ADDENDUM NO. 1 June 6th, 2024

PROJECT: ANSON INDEPENDENT SCHOOL DISTRICT VOC. TECH RENOVATION

The following changes and/or additions shall be made to the Plans, Specifications, and Contract Documents for the above referenced project. Bidder shall acknowledge receipt of this Addendum on the Construction Costs Form.

T							1BPEFIKM 1BAEFIKM 1BPELSFIKM # 2448 # BR 2261 # 10194493
			VOC. TECH RENOVATION	-			
	DATE	6/6/2024					BAR IS ONE INCH IN LENGTH ON ORIGINAL DRAWING.
l	S NO. REVISION	2 1 ADDENDUM 1		 	 EET A 2	2.	O PROJECT# SCALE 23231 As Indicated

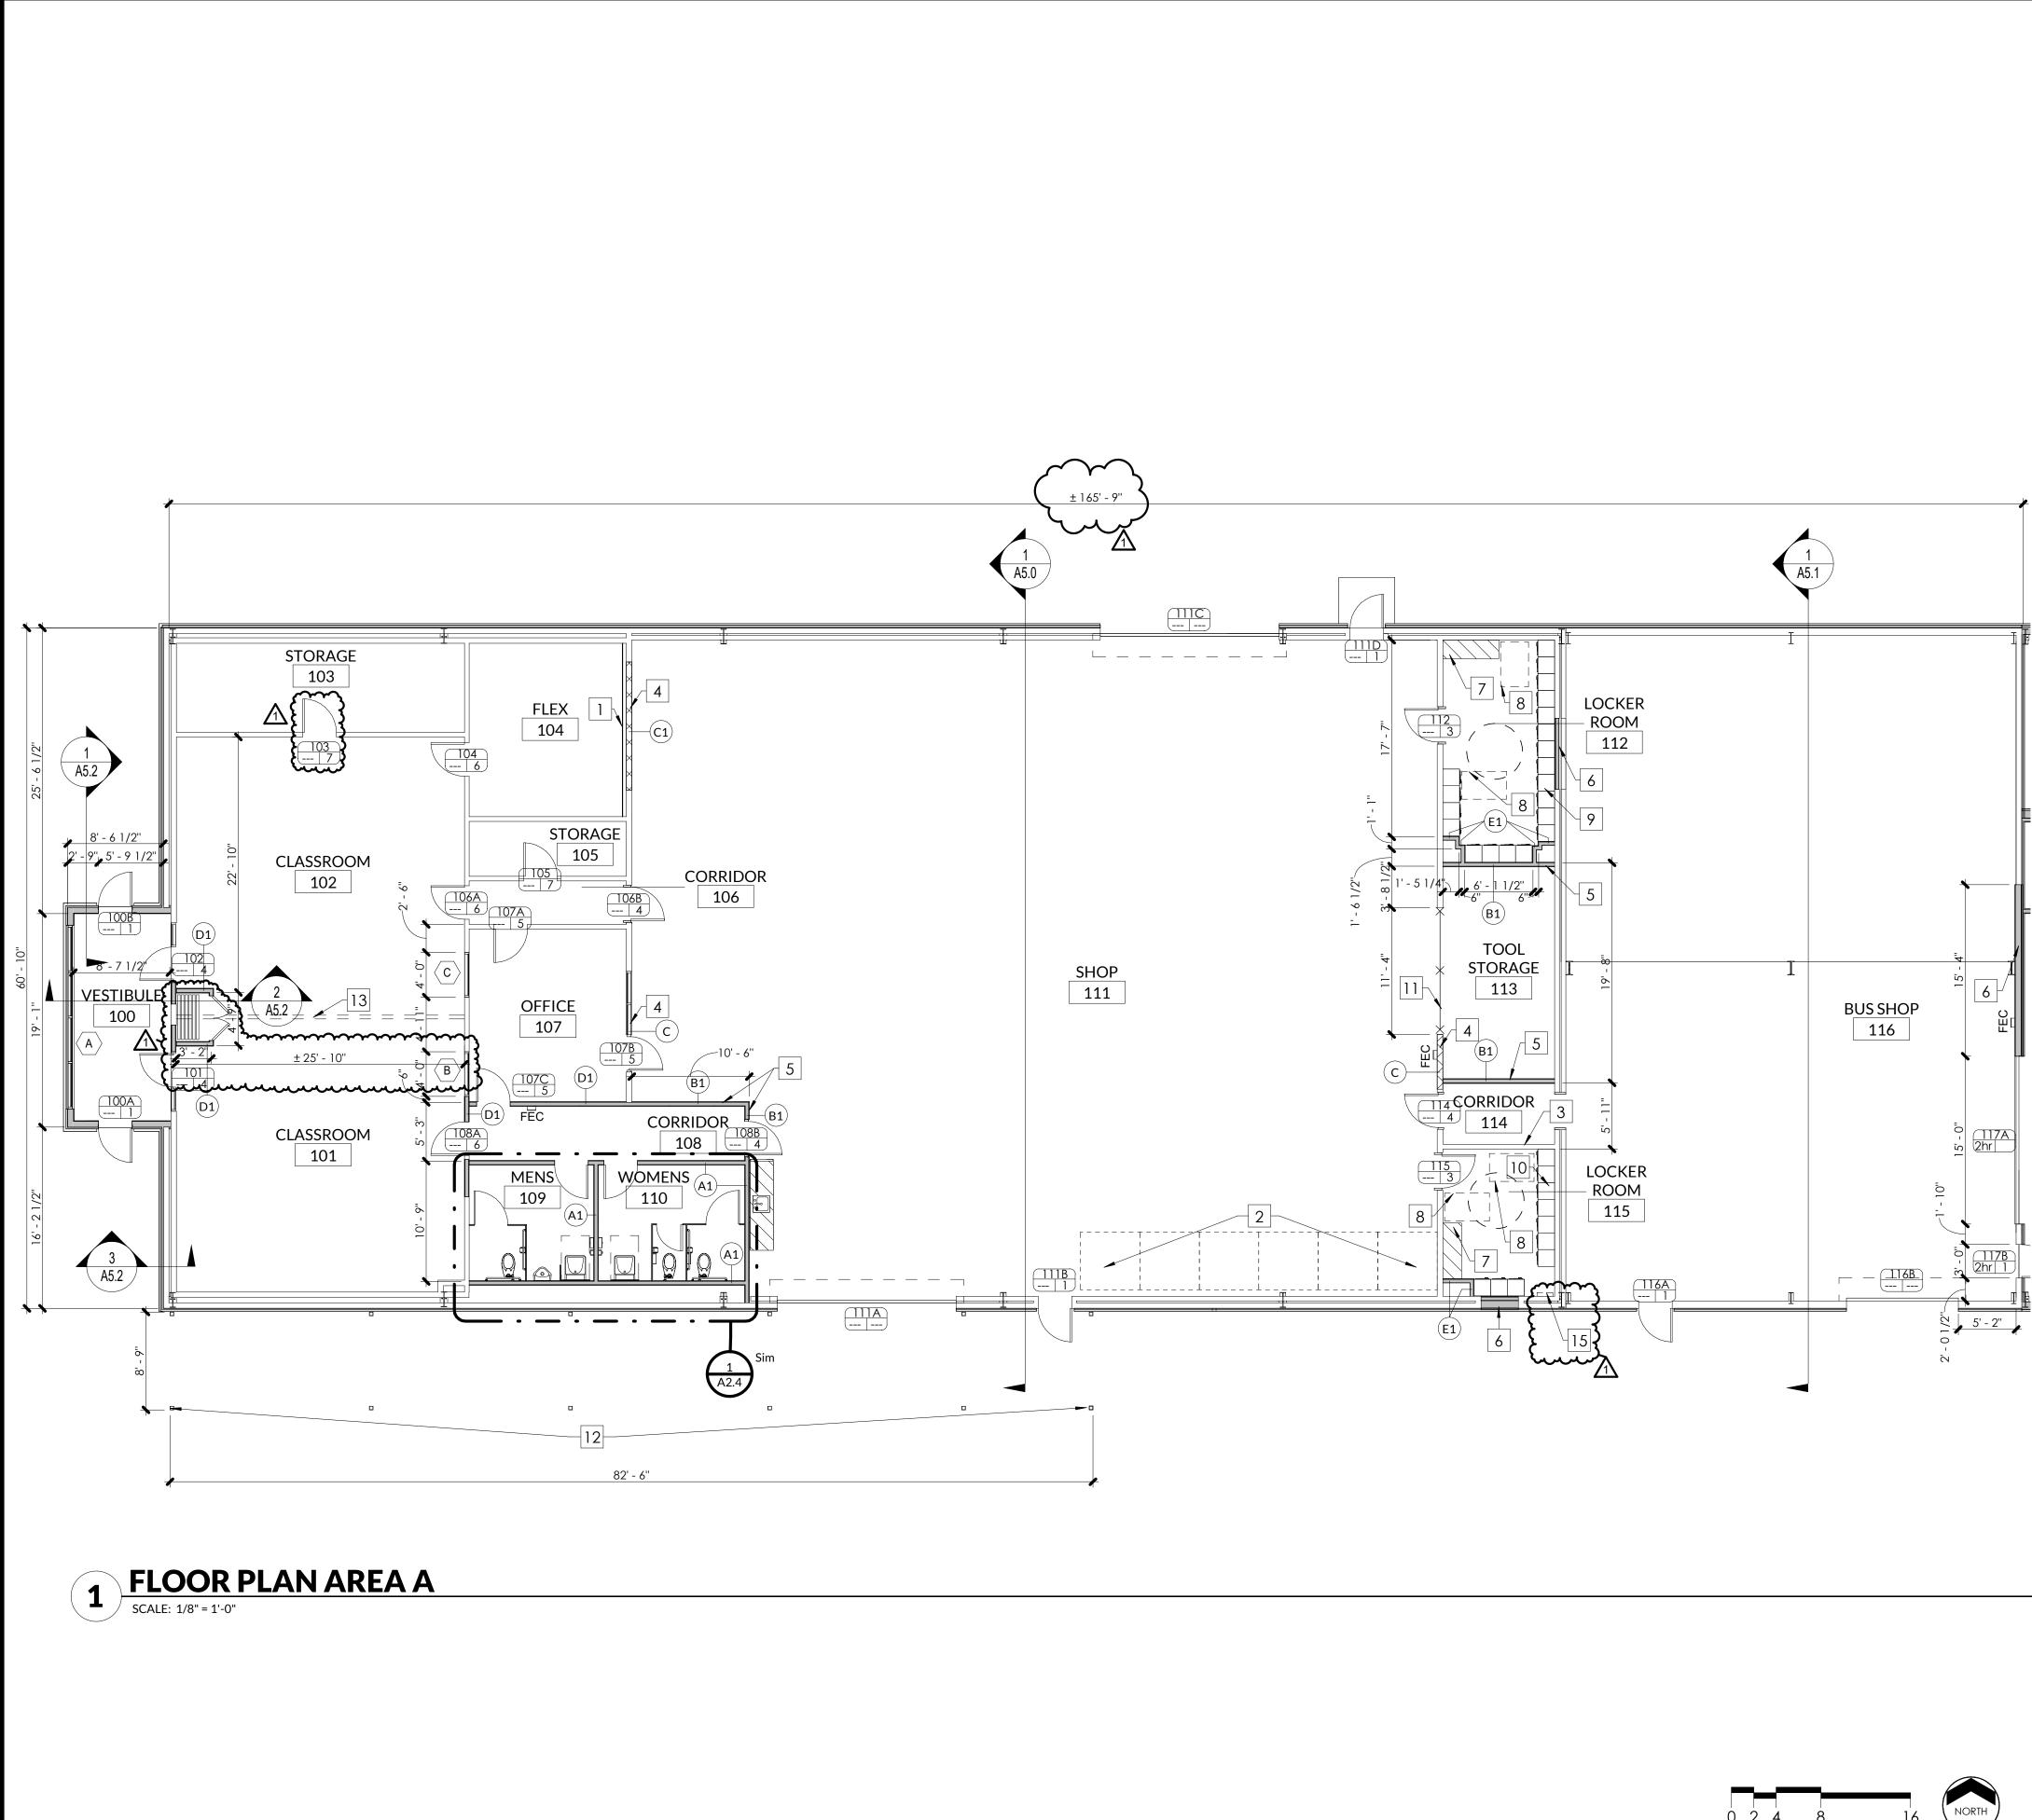
Item #D2	Sheet A2.2 – REPLACE sheet with attached sheet A2.2 dated 06-06-2024. UPDATED floor plan & keyed notes to show missing dimensions, pocket enclosure doors for partition wall, existing electrical J box, new door 103, and chain link fence clarification.

ART ЩĊ ≚ % AE B R CH RENOVATION AN Ч OR ON ISD Õ ANS Ξ ш \triangleleft RE \triangleleft 0 N Ŋ. SHEET A2.3

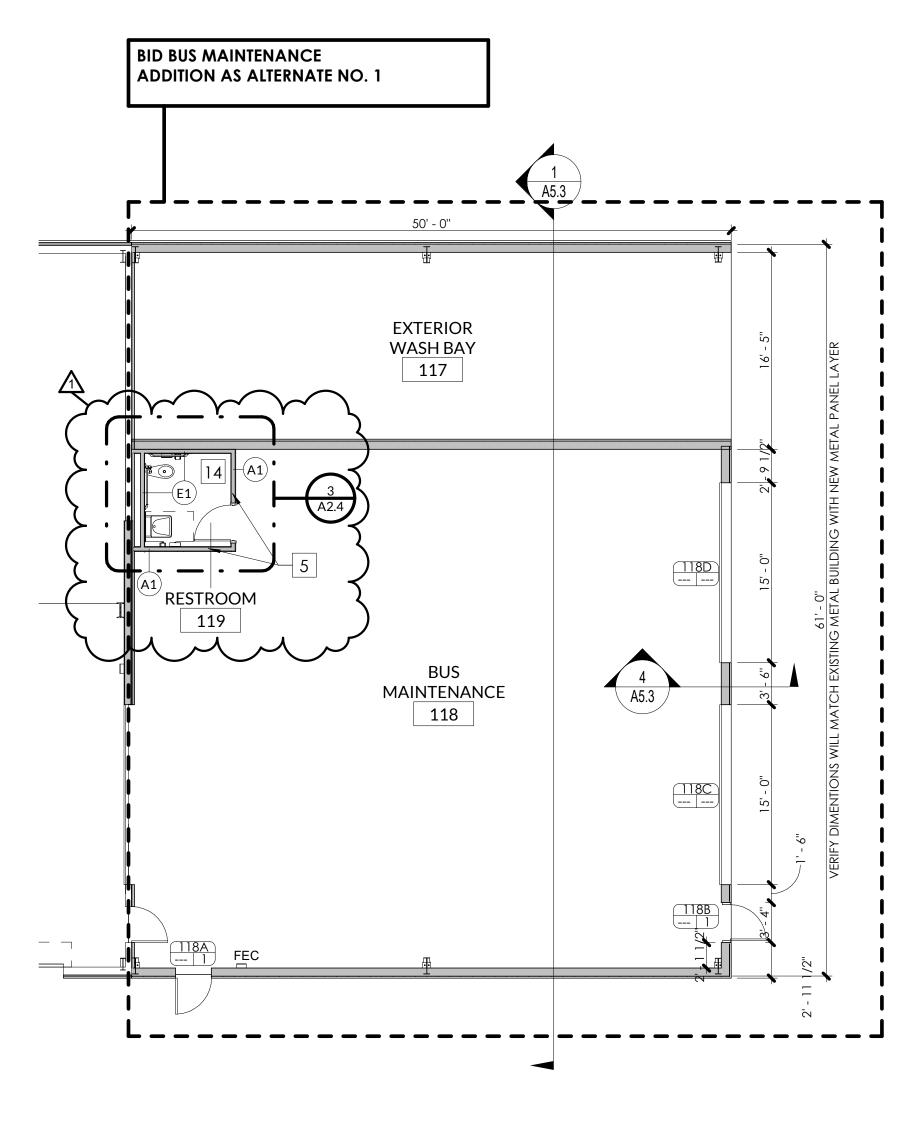
Item #D3	Sheet A2.3 – REPLACE sheet with attached sheet A2.3 dated 06-06-2024. UPDATED floor plan to show missing partition tags.		
Item #D4	Sheet A2.4 – REPLACE sheet with attached sheet A2.4 dated 06-06-2024. UPDATED millwork elevation showing missing dimensions.

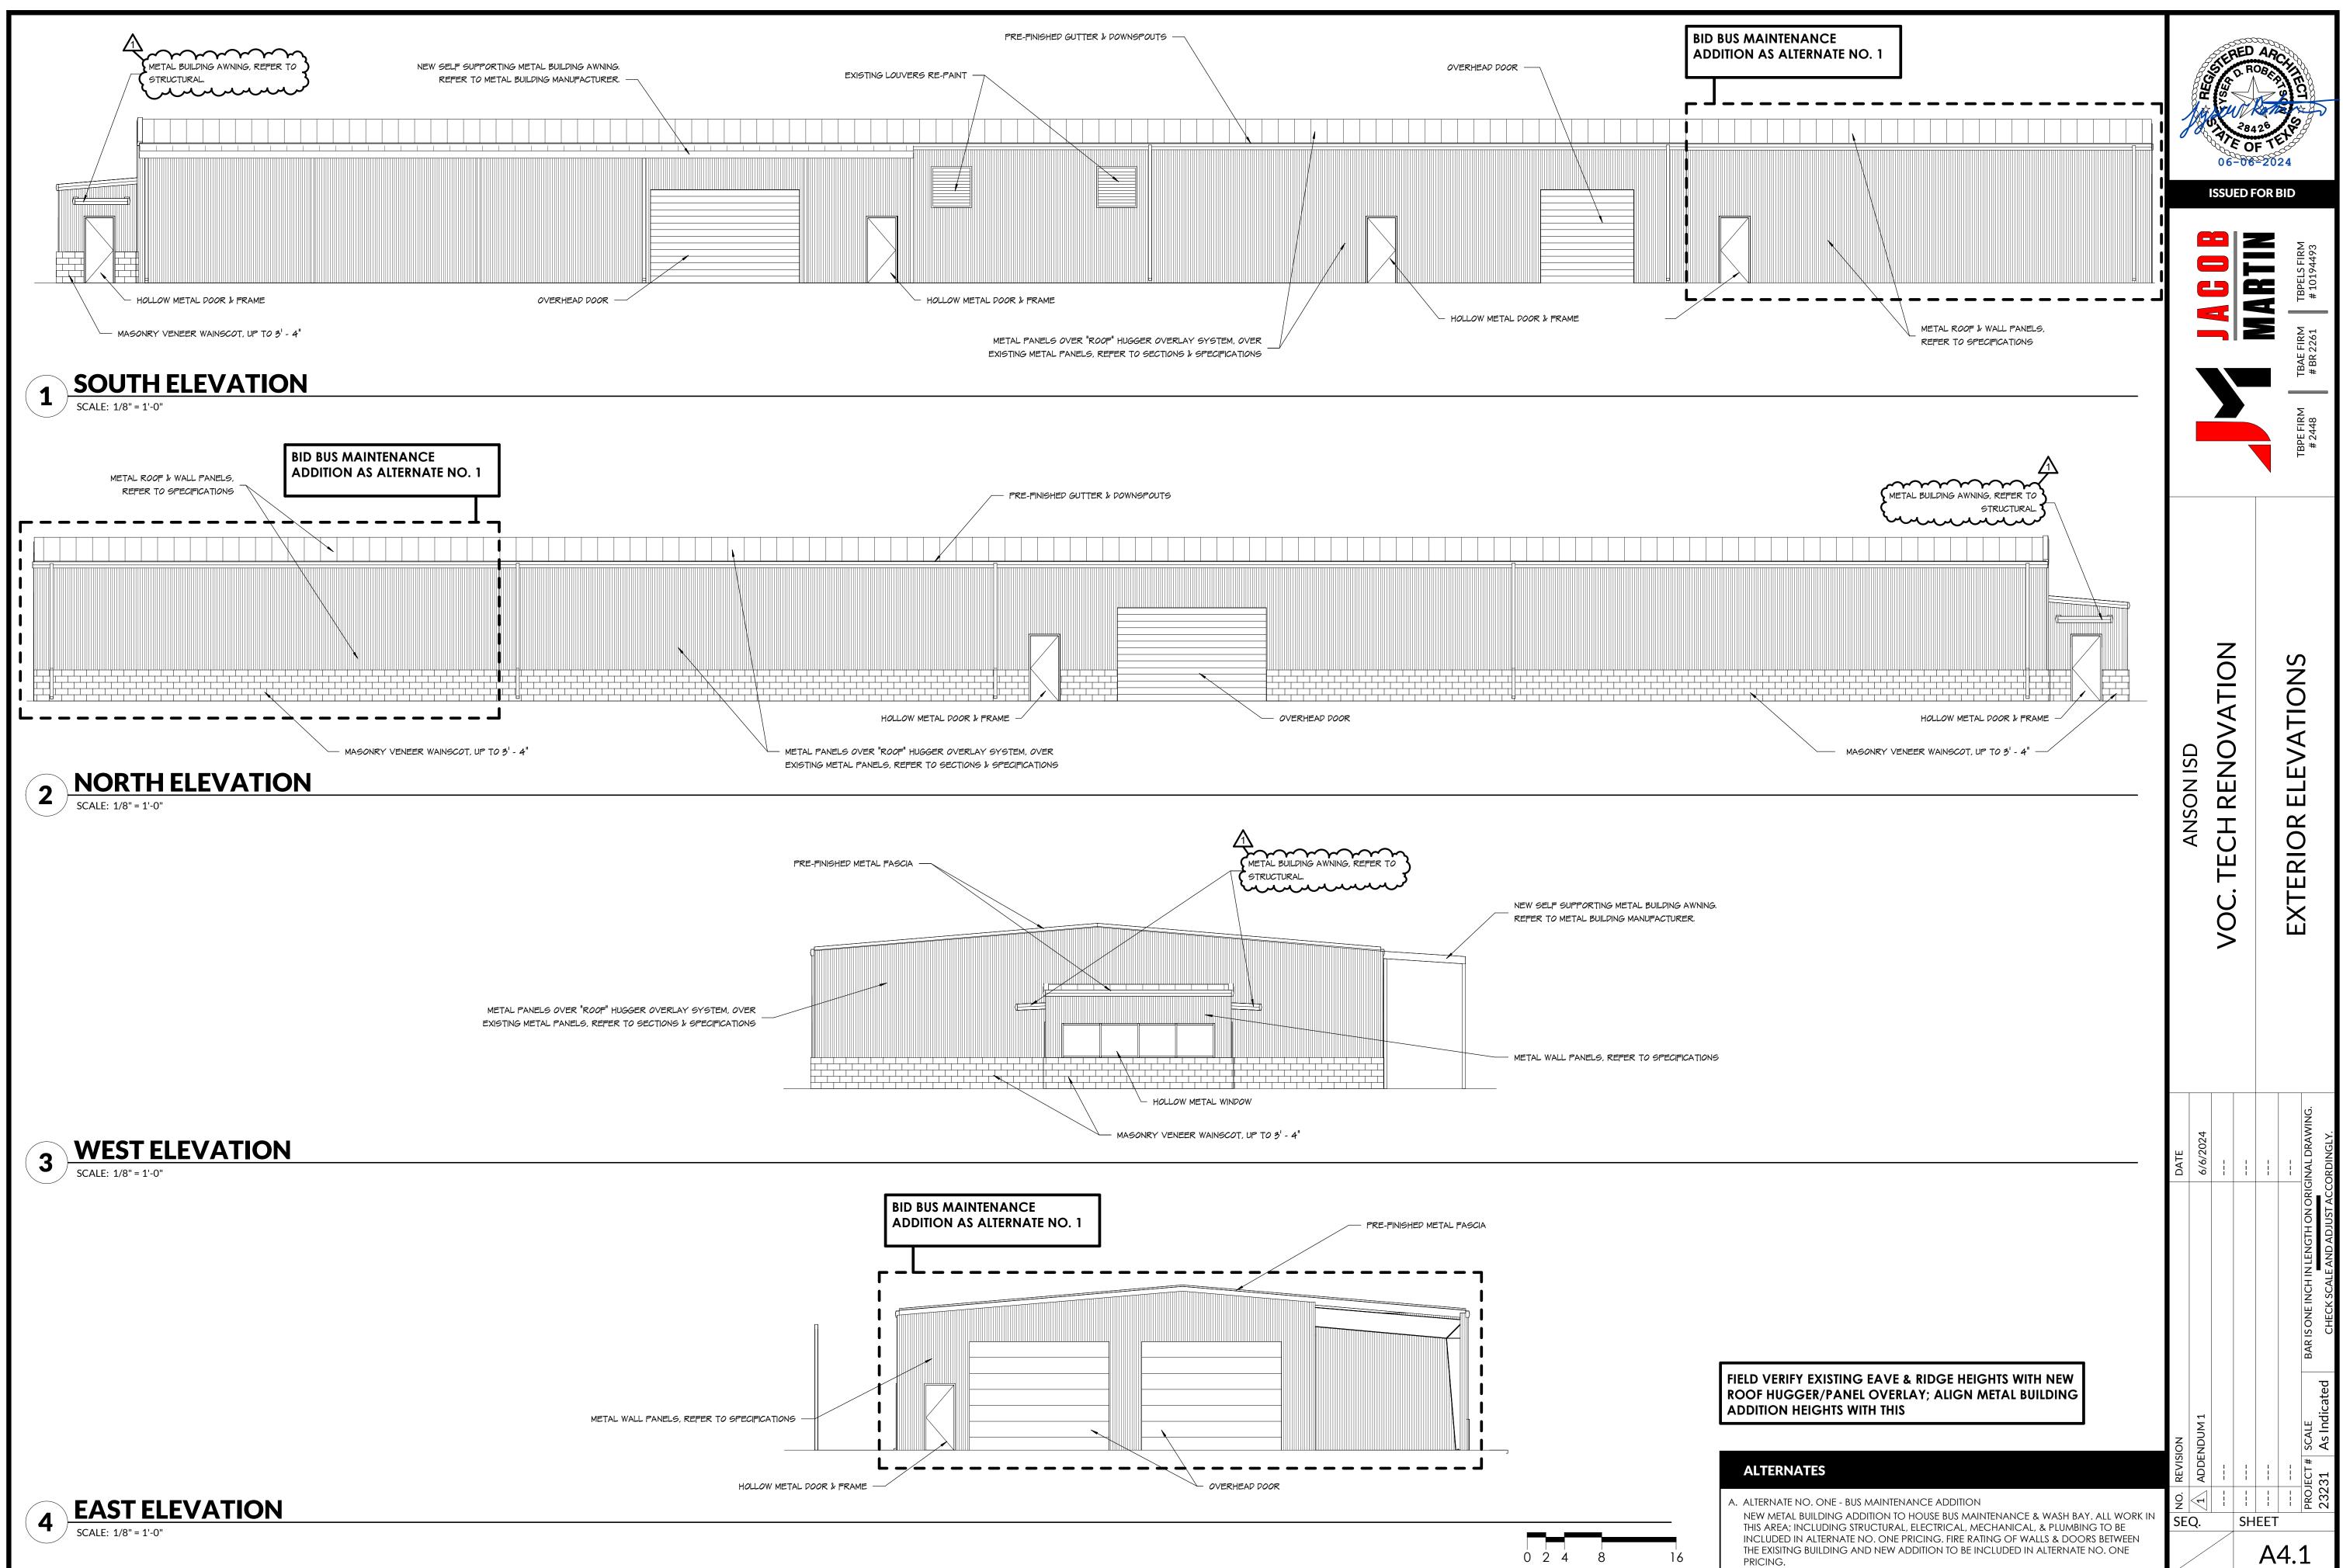
Item #D7	Sheet A7.1 – REPLACE sheet with attached sheet A7.1 dated 06-06-2024. UPDATED reflected ceiling plan & keyed notes to show revised awning note and missing smoke detector note.
